PRODUCT REFERENCE BOOK

for the Tektronix Type

422

oscilloscopes

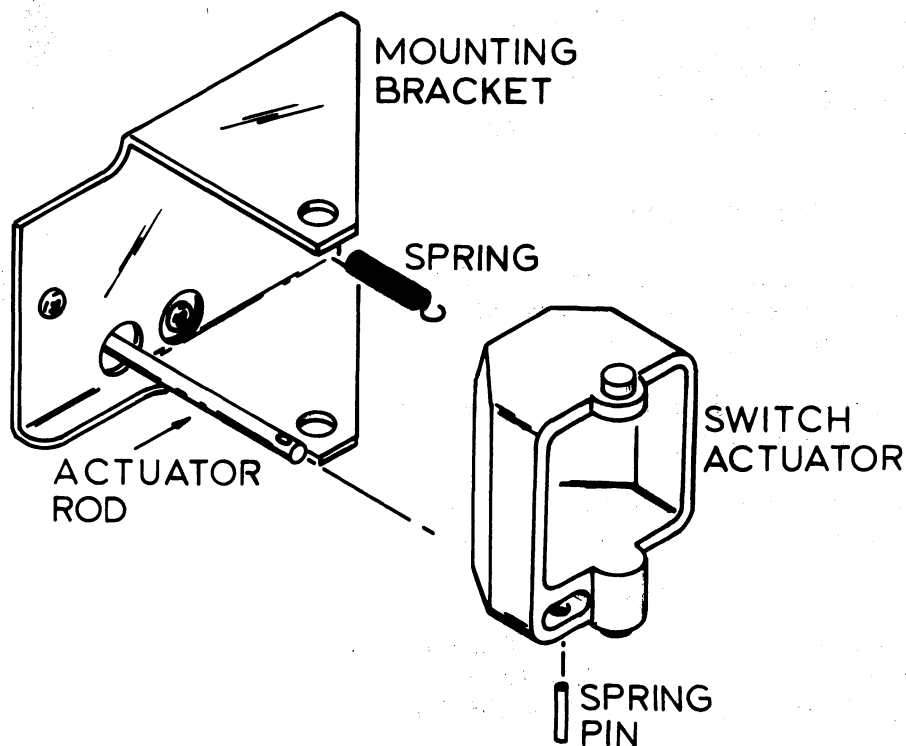
This modification provides an improved POWER switch actuator assembly, which eliminates failure of the 'press-fit' pivot pin.

The switch actuator and actuator rod have been modified to use a spiral spring pin.

- () 1. Disconnect the power supply and remove from the rear of the instrument.
- () 2. Remove the cabinet.
- () 3. Replace the POWER switch actuator, actuator rod and pivot pin, located on the rear of the instrument, with those from the kit. Refer to drawing.

NOTE: The 'spiral' spring pin can be easily installed, using a pair of pliers.
'Compress gently' and insert pin into the actuator rod. Refer to drawing.

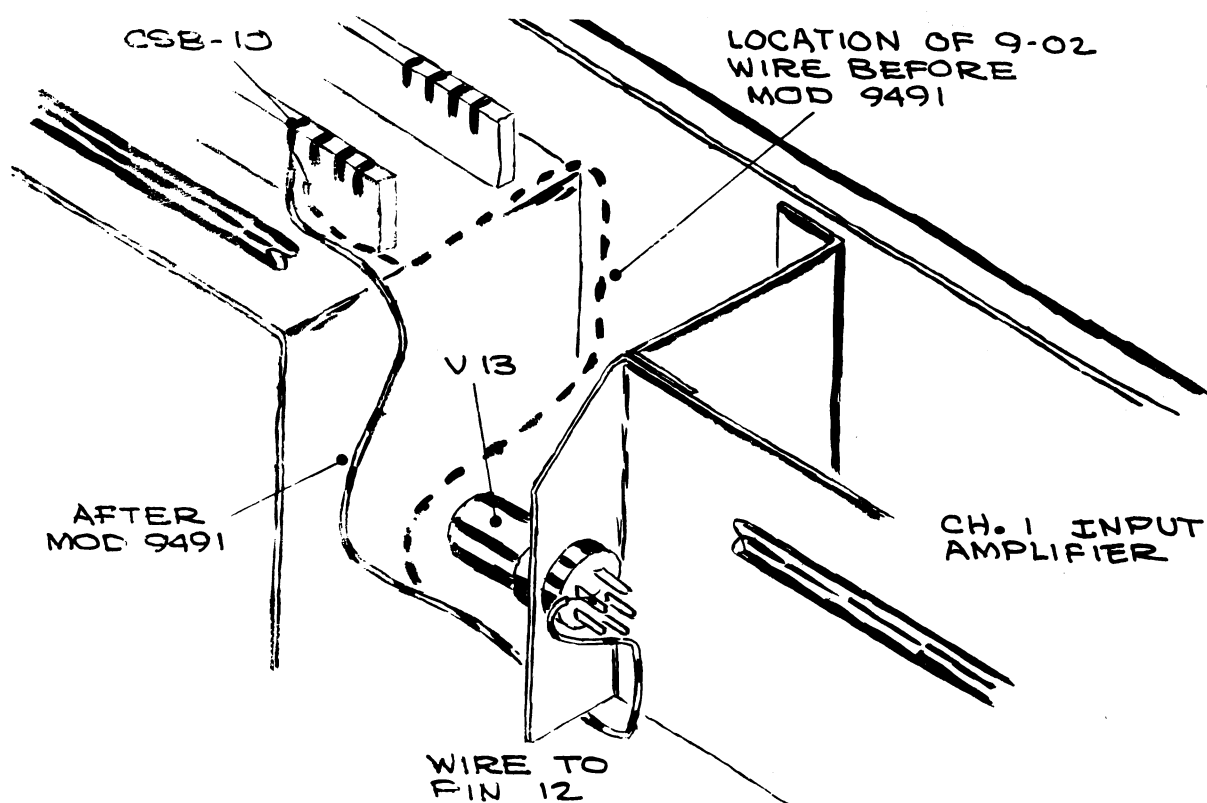
Sweep start transients are being fed into the vertical amplifier by way of the filament wire of V13 and the wire from connector M, Cal Board to connector D, Ch 2 Input Amp Board.

The sweep feed-through is reduced by:

BEFORE
M9333

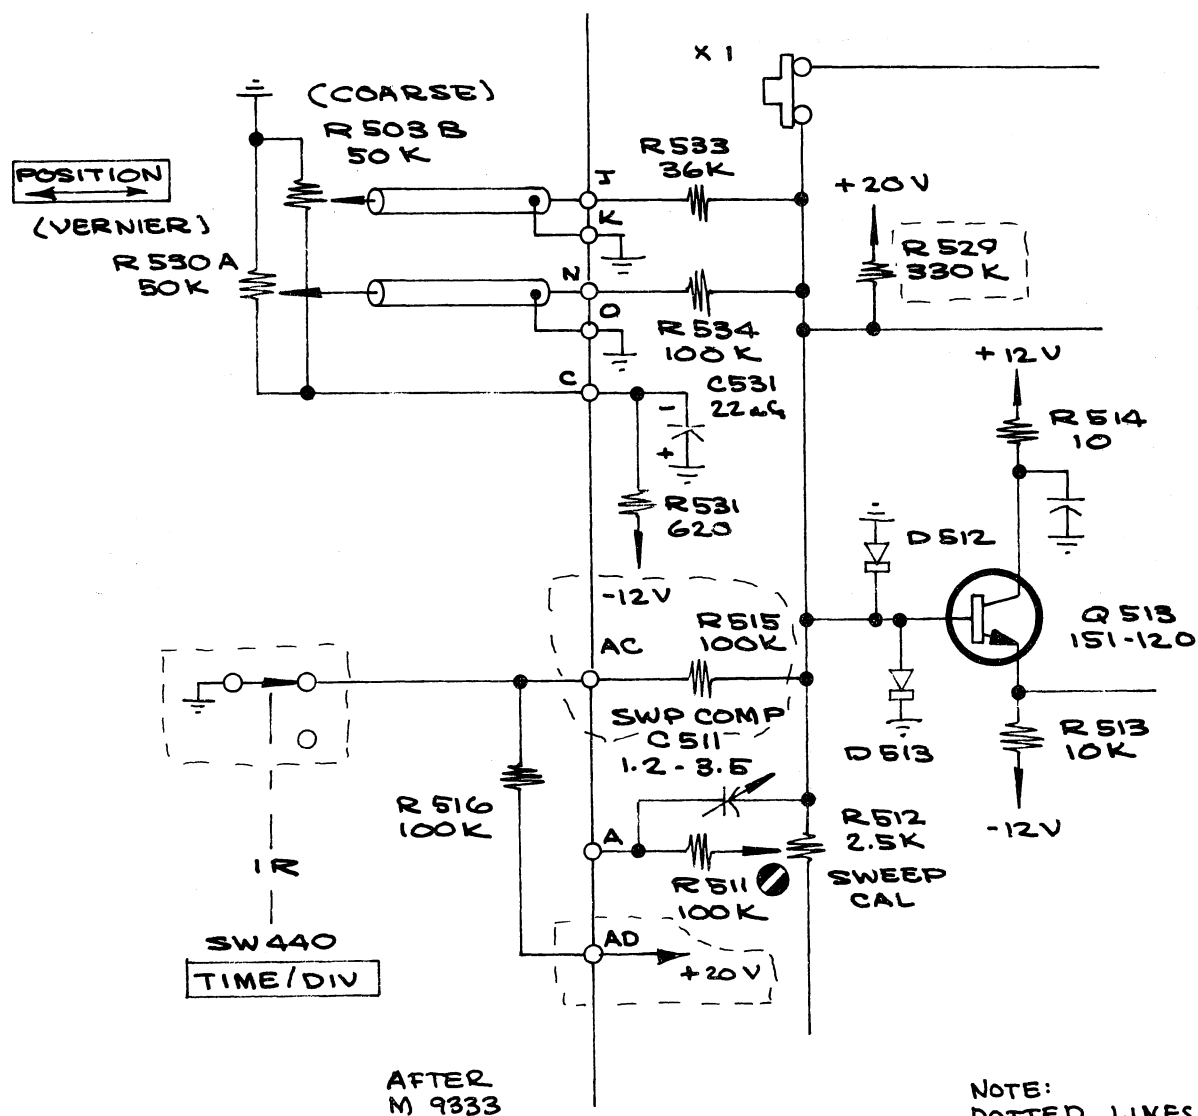
See Before and After schematics on following pages.

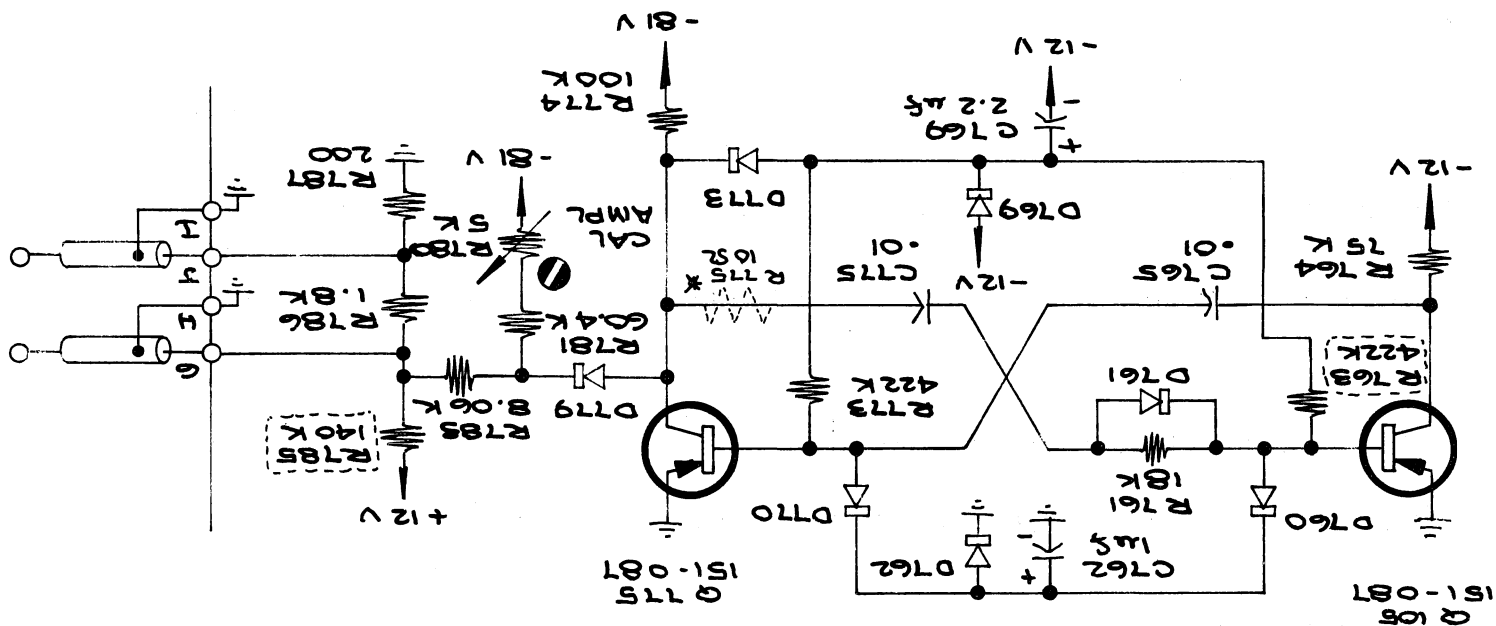
*NOTE: M 9334 DELETES R715
FIELD INSTALLATIONS
REPLACE IT WITH A
10 Ω , 1/4 W 5% RESISTOR
DOTTED LINES INDICATE
RESISTOR VALUE CHANGES

FIG. 1

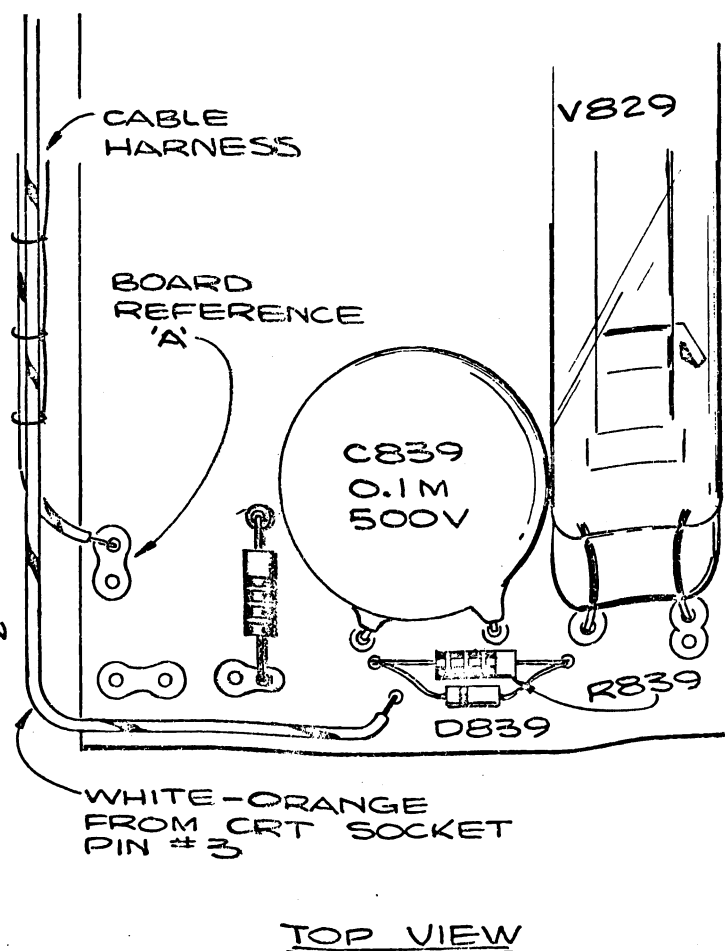
CRT CIRCUIT ZENER DIODE AND
RESISTOR ADDED TO ELIMINATE
CHANGE IN DEFLECTION SENSITIVITY

- Remove the HV Power Supply assembly from the instrument.
- Remove the "DANGER HIGH VOLTAGE" cover (337-721) from the HV Power Supply assembly.
NOTE: For future reference, observe how the HV circuit boards and HV transformer are mounted in the plastic container.
- Remove the HV circuit boards and HV transformer from the plastic container.
MAKE THE FOLLOWING CHANGES TO THE
HIGH VOLTAGE REGULATION CIRCUIT BOARD:
- Remove approximately 3/16" of the circuit run (with an X-acto[®] blade or equivalent) as shown in Fig. 1.

FIG. 2

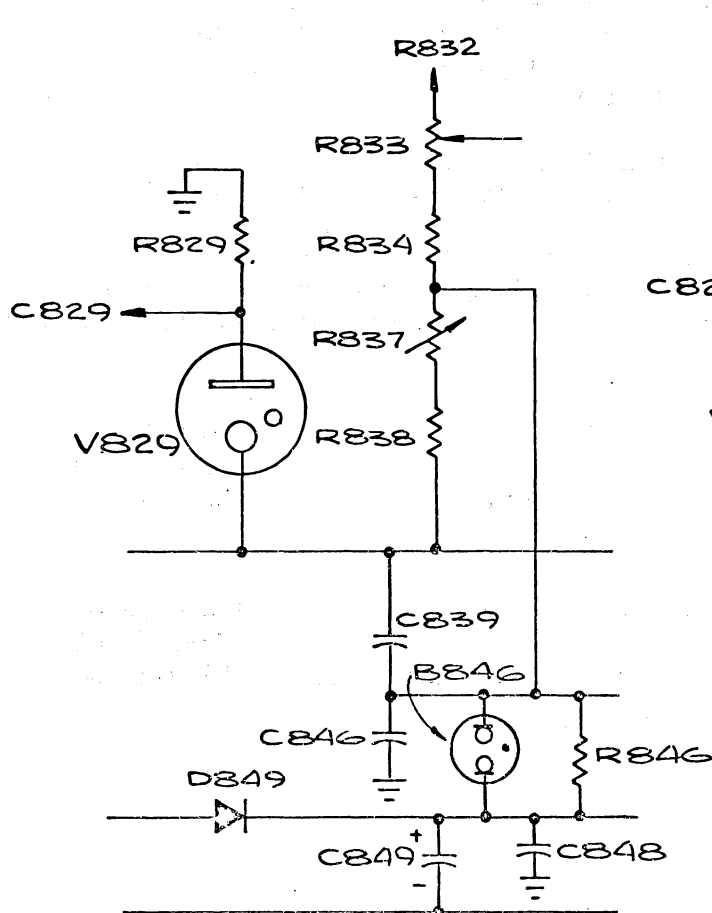
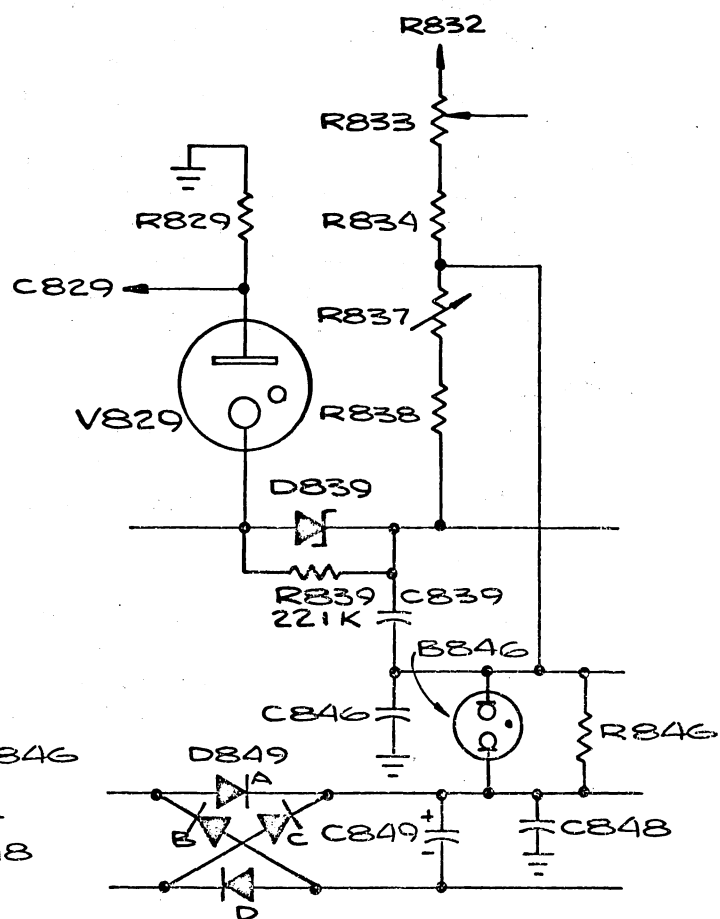
- g) Add D839 (51V 5% 400mW Zener diode) and R839 (221 k 1/8 W 5% metal film resistor) in parallel between the two eyelets. Banded end of Zener diode toward C829. Solder eyelets (see Fig.2).

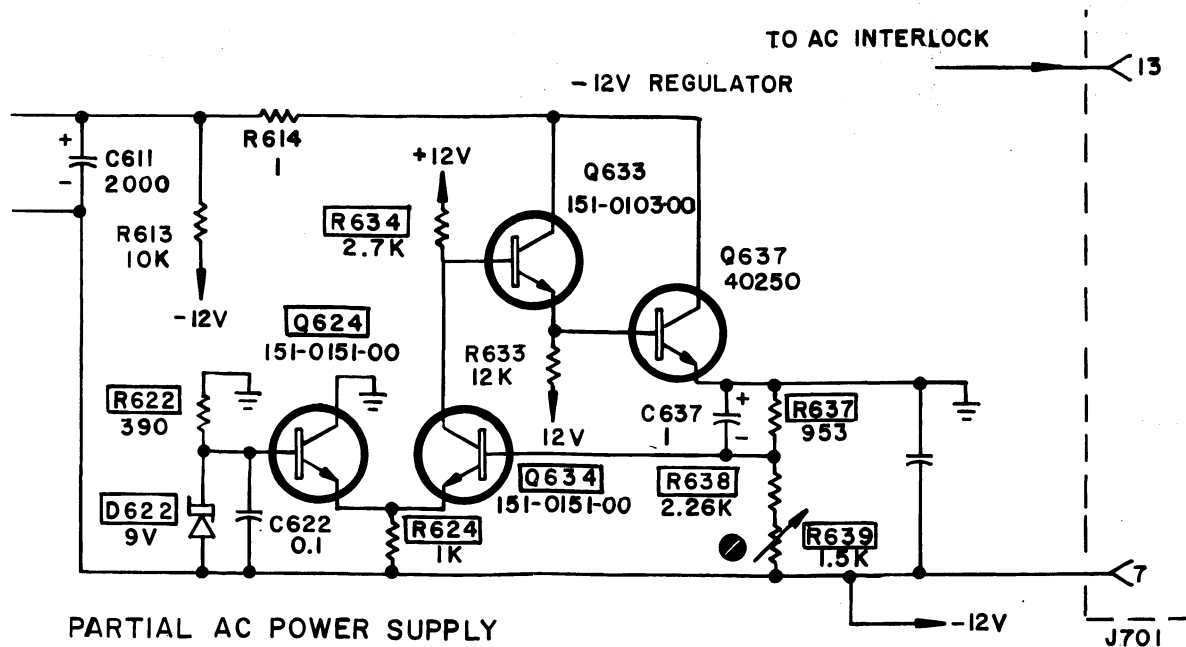
- 1) Change R639 from a 2.5 k composition potentiometer to a 1.5 k wirewound potentiometer.
- 2) Change R622 from 1 k 1/4W 5% to 390Ω 1/4W 5%.
- 3) Change R634 from 2.4 k 1/4W 5% to 2.7 k 1/4W 5%.
- 4) Change R624 from 620Ω 1/4W 5% to 1 k 1/4W 5%.
- 5) Change R638 from 4.02 k 1/8W 1% to 2.26 k 1/8W 1%.
- 6) Change R637 from 6.34 k 1/8W 1% to 953Ω 1/8W 1%.
- 7) Replace D622 with a 1N936 zener diode as needed.

FIG. 1

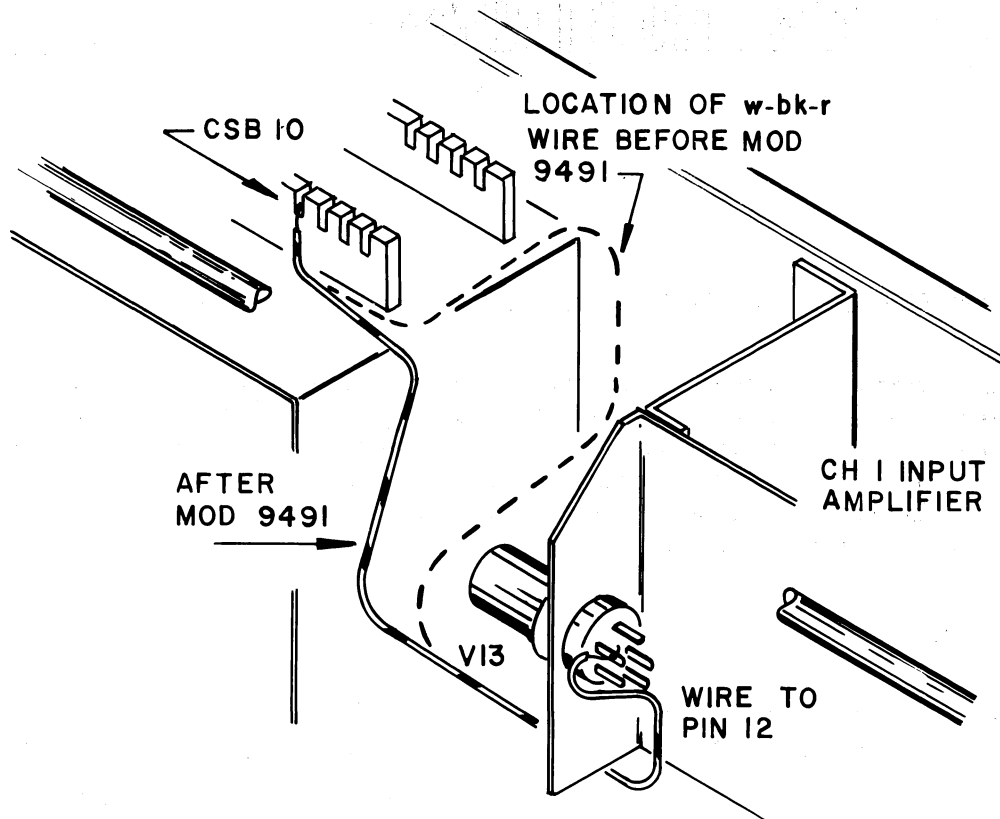
- 4) Remove the #26 white-red-black-black wire from pin M of the Calibrator-Regulator board, located behind the timing switch.
- 5) Cut the connector off of the wire immediately behind the connector and remove the wire from its cable back to the point where the cable passes below a 3/8" grommet in the instrument chassis near pin Y of the Sweep Trigger/Generator circuit board. See Fig. 2.

FIG. 2

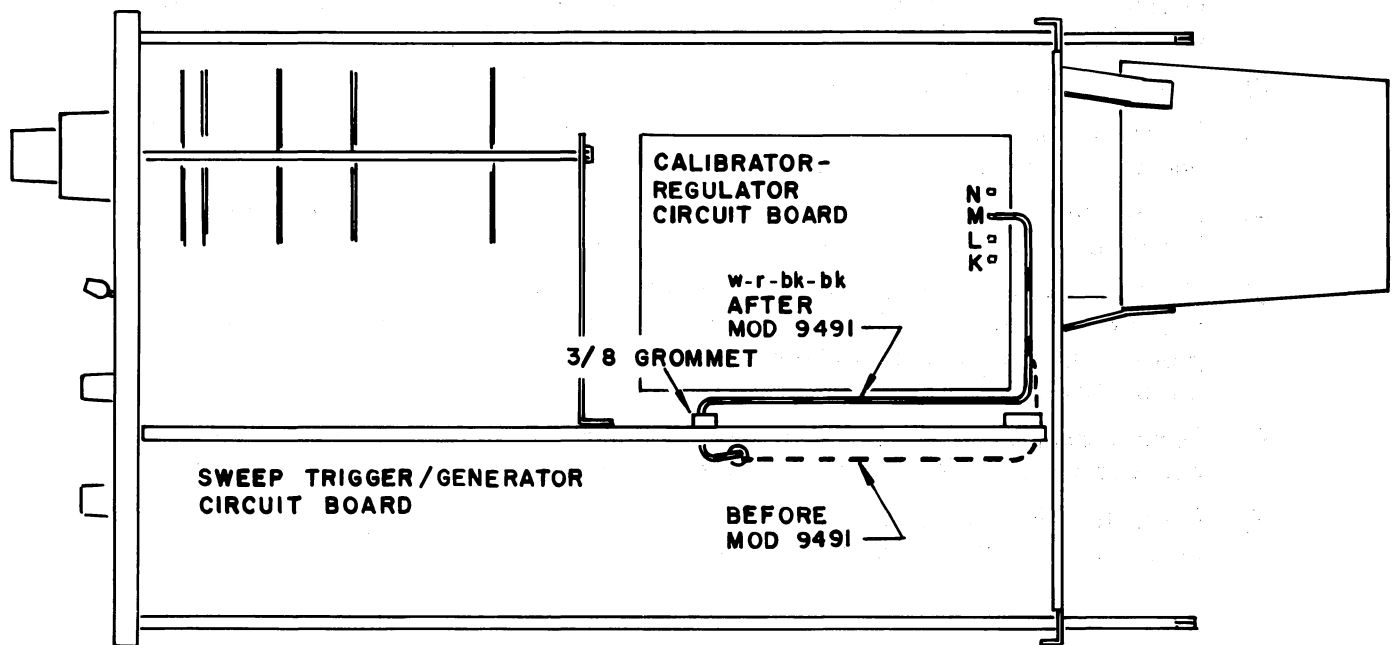
- 7) Dress the wire through the 3/8" grommet and along the chassis as indicated in Fig. 2 and re-install the wire on pin M of the Calibrator-Regulator board.

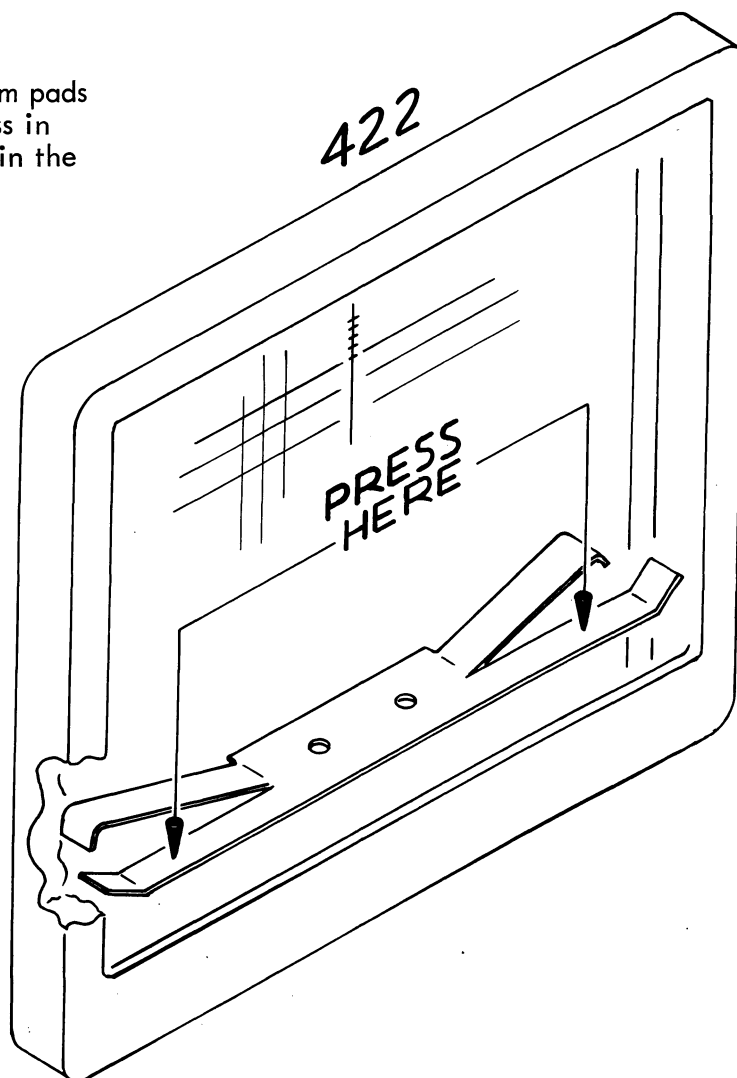
Remove the adhesive backed foam pads from in front of the CRT and press in the new support spring as shown in the illustration.

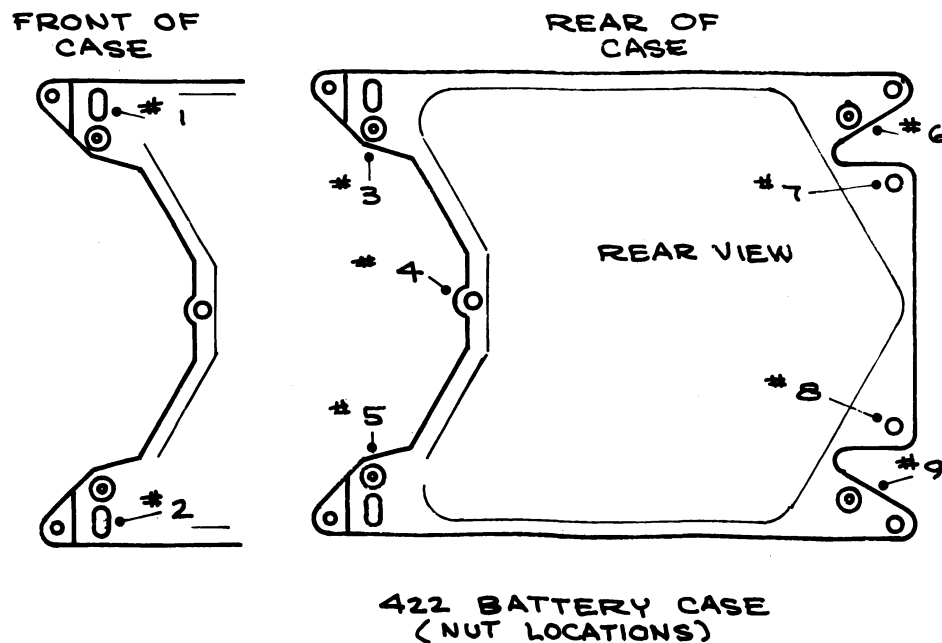
Replace the nine 6-32 x 1/4 cad plated brass nuts, used for assembling the battery pack, with nine 6-32 x 1/4 stainless steel nuts.

FIG. 1

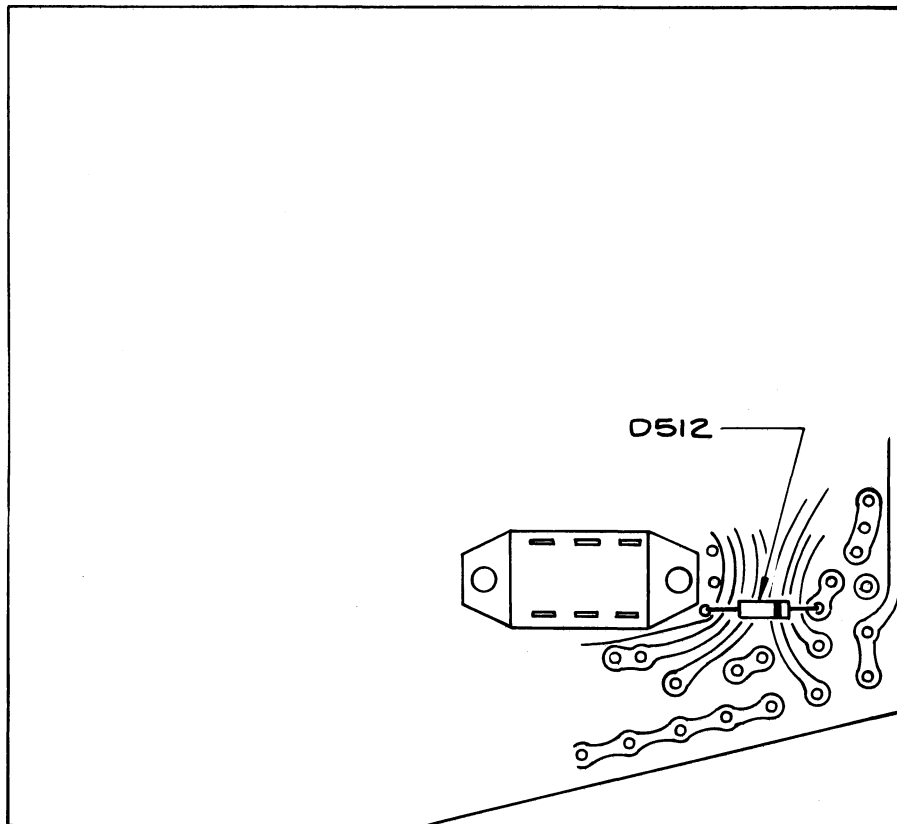
- 1) Remove D512, a 6185 diode, from its location as shown in Fig. 1.
Save for later use.
- 2) Remove the three mounting screws from the Horizontal Amplifier circuit board and lift the board so the bottom side is readily accessible.
